**ARIZONA NUCLEAR POWER PROJECT  
PALO VERDE NUCLEAR  
GENERATING STATION**

**ELEMENTARY DIAGRAM  
SAFETY INJECTION & SHUT DOWN CLG SYS  
HYDRAZINE PMP TO CONTAINMENT SPRAY PMP  
VALVES J-SIA-UV-681 & J-SIB-680**

PALO VERDE NUCLEAR GENERATING STATION UNITS 1, 2 & 3  
DRAWING CHANGE NOTICE (DCN)  
JOB NO. 10407

DRAWING NO.	SHEET NO.	REV.	DCN NO.
13-E-SIB-037		3	7

SCALE NONE	JOB NO.	DRAWING NO.	REV.
	10407	13-E-SIB-037	3

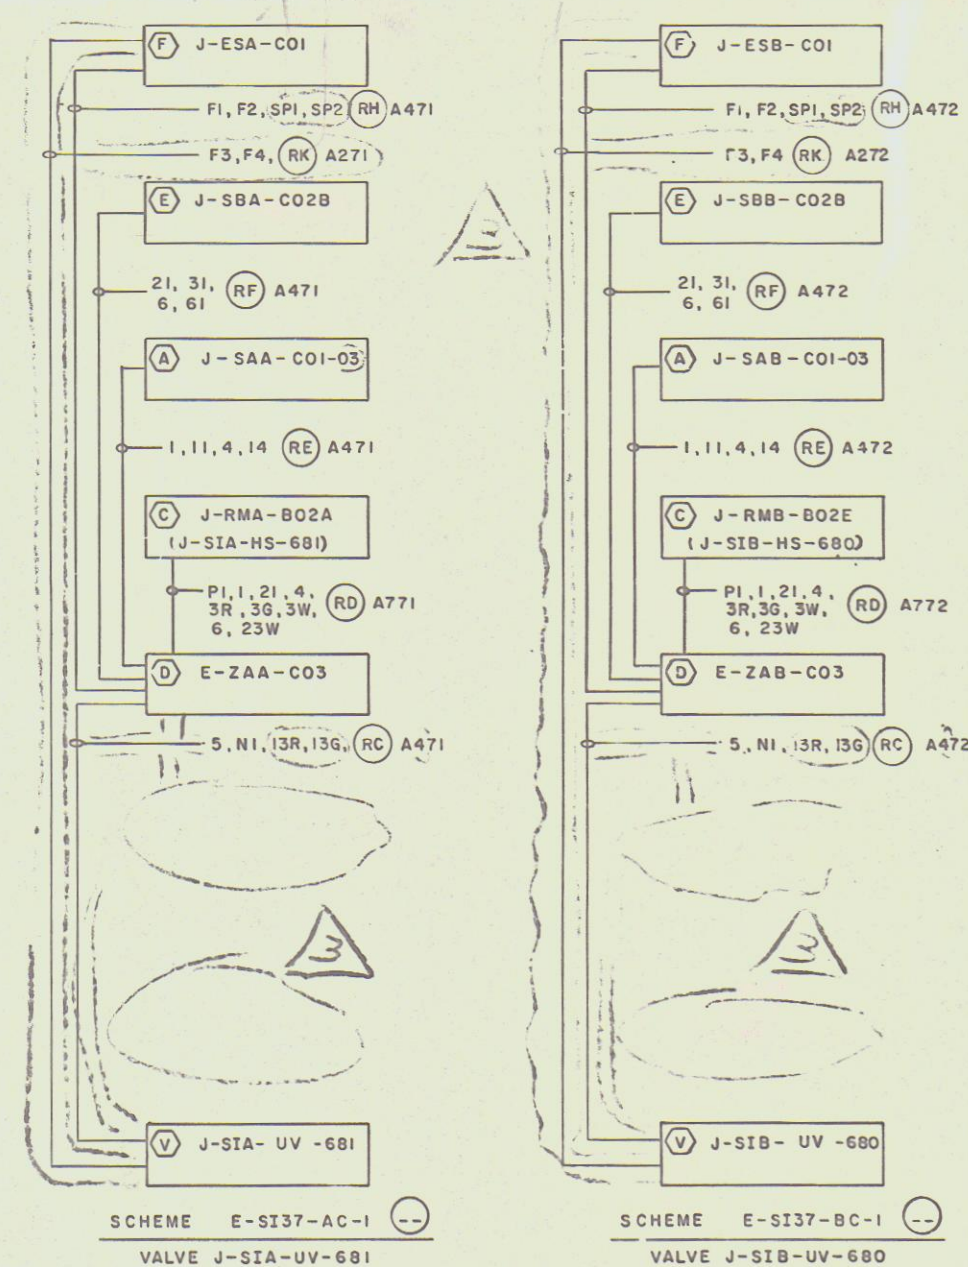
REASON FOR CHANGE: ICSB DRAWING REVIEW (TASK # 34)

DESCRIPTION OF CHANGE: CHANGE START-STOP CONTROL CIRCUIT PER THE FOLLOWING:

WAS:

IS:

SCHEME E-5137-BC-1  
VALVE J-SIB-UV-680

SCHEME E-5137-AC-1  
VALVE J-SJA-UV-681
